Staff Report

Infill Housing Design Review Committee

File Number: 8-D-23-IH

Location: 1723 Texas Ave. **Parcel ID** 81 P D 032
Zoning: RN-2 (Single-Family Residential Neighborhood)
District: Lonsdale Infill Housing Overlay District

LeMAY & ASSOCIATES CONSULTING ENGINEERS 10816 KINGSTON PIKE KNOXVILLE, TN. 37934 PH: 865-671-0183	PLOT PLAN		DATE: 7-20-2023
	LOTS 13 & 14		SCALE: 1" = 30'
	<i>LONSDALE ADDITION</i>		DWG. NO. 6304
	1719-1713 TEXAS AVE. KNOXVILLE, TN 37921		DRAWN BY: RELjr.

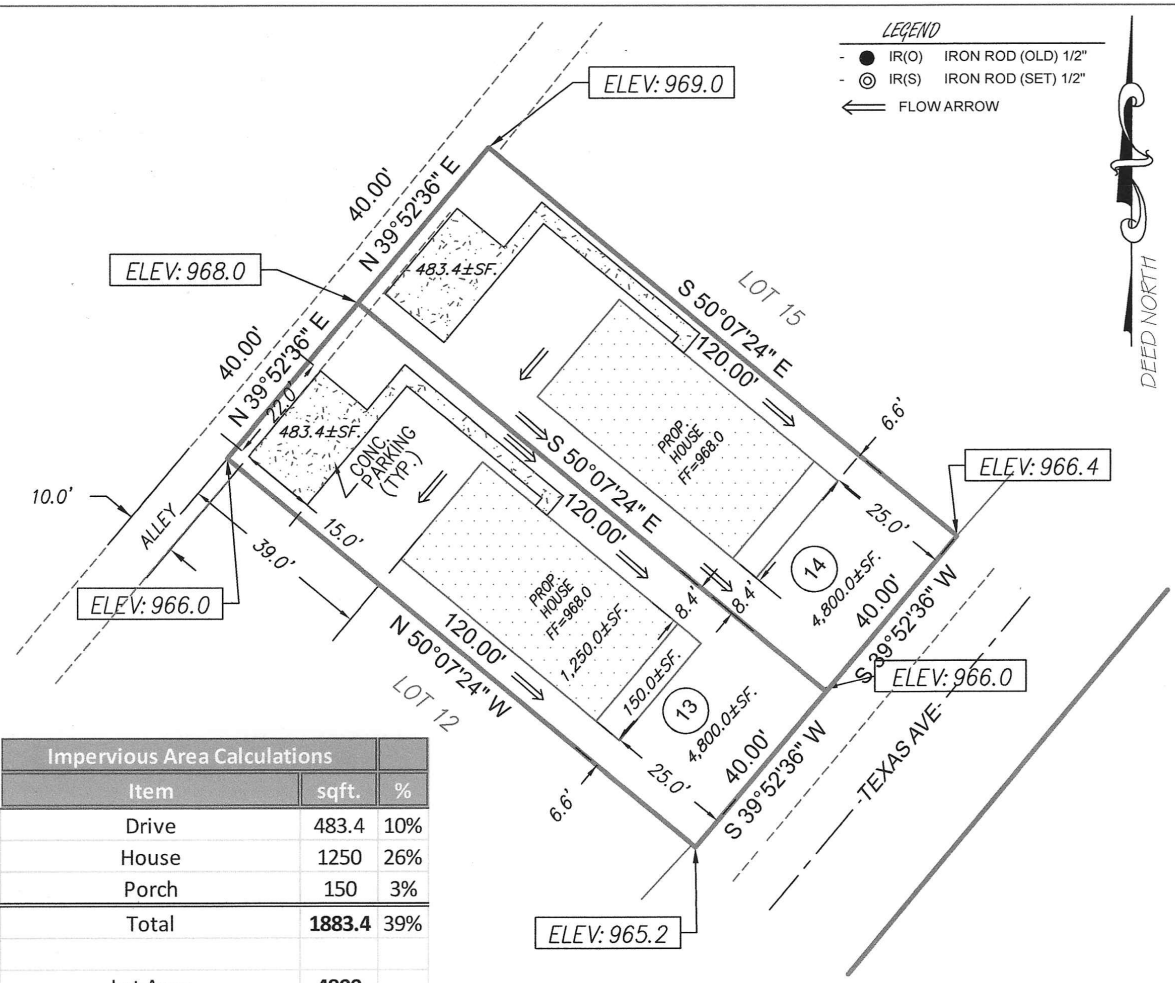
1. The edge of the front porch is proposed to be set 25' from the front property line, so the main massing of the house will be set 33' from the front property line. The average front setback of the block is 24.5', also measuring to full-length front porches on the houses. The new house's front setback will maintain a consistent streetscape pattern with houses on the block. The final site plan should include a walkway to the street.

3. The proposed parking meets Infill Housing design guidelines as the parking pad is accessed from the alley and located to the rear of the house. Final revisions to the site plan may be necessary to meet City Engineering standards.

9. The final site plan should indicate one new native or naturalized shade tree to be planted in both front and rear yards.
10. The house is proposed to be identical to the adjacent new construction house at 1719 Texas Ave (8-C-23-IH). Revisions should be made to the two houses to introduce differentiation in design; options include revised rooflines, porch design and placement, or house massing.

Staff recommends approval of Certificate 8-D-23-IH, subject to the following conditions: 1) final site plan to meet City Engineering standards; 2) foundation to reflect foundation height of existing houses on block and be clad in stucco; 3) final siding materials to meet Infill Housing design guidelines; 4) revisions to placement of side elevation windows, with approval by staff; 5) revisions to differentiate from adjacent new house at 1719 Texas Avenue, with approval by staff.

EXTERIOR
 ELEVATIONS

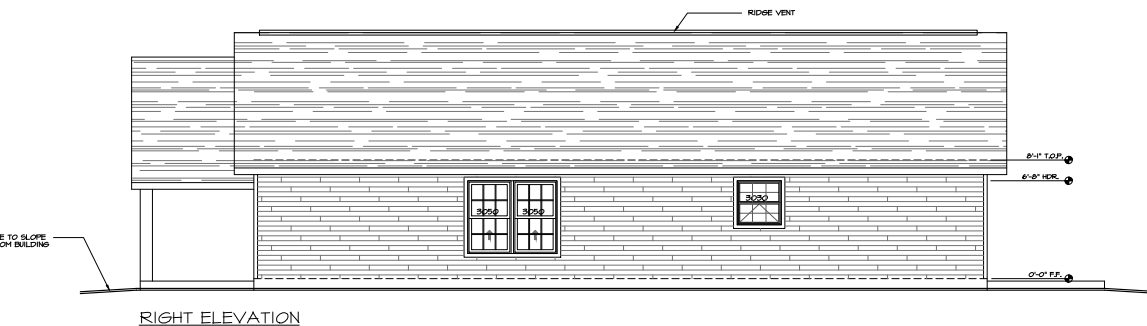
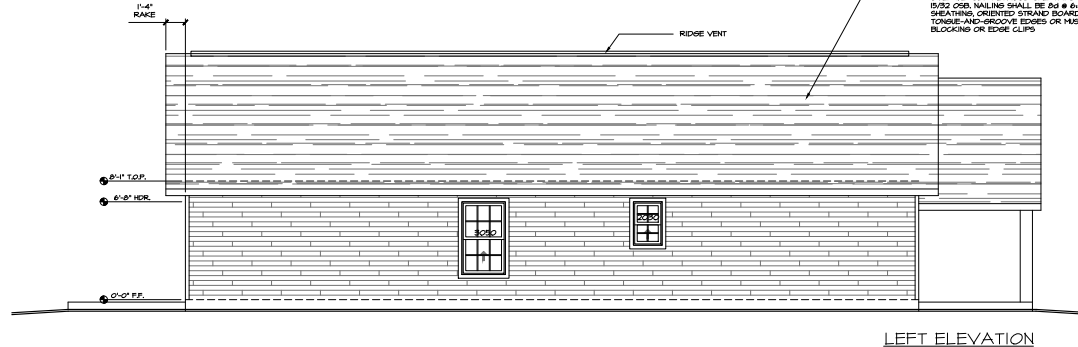
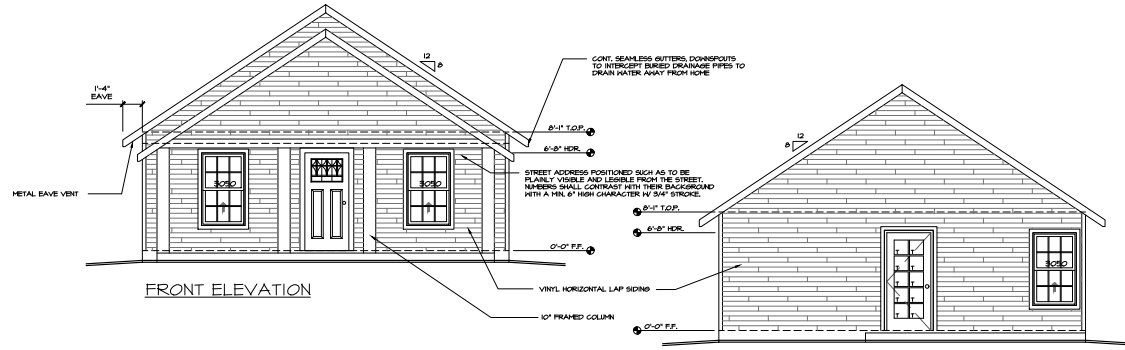
6. Guidelines recommend window and door styles be similar, with similar proportions and ratio of solid to void, to historic houses on the block. The proportions of windows and door on the façade meet the guidelines. Revisions are necessary to side elevation window placement to avoid large swaths of siding with no transparency.

7. The proposed roof pitch and material are appropriate within the guidelines.
8. The elevation drawings do not specify a siding material. The applicant should specify siding materials, referring to page 13 of the Infill Housing Design Guidelines.
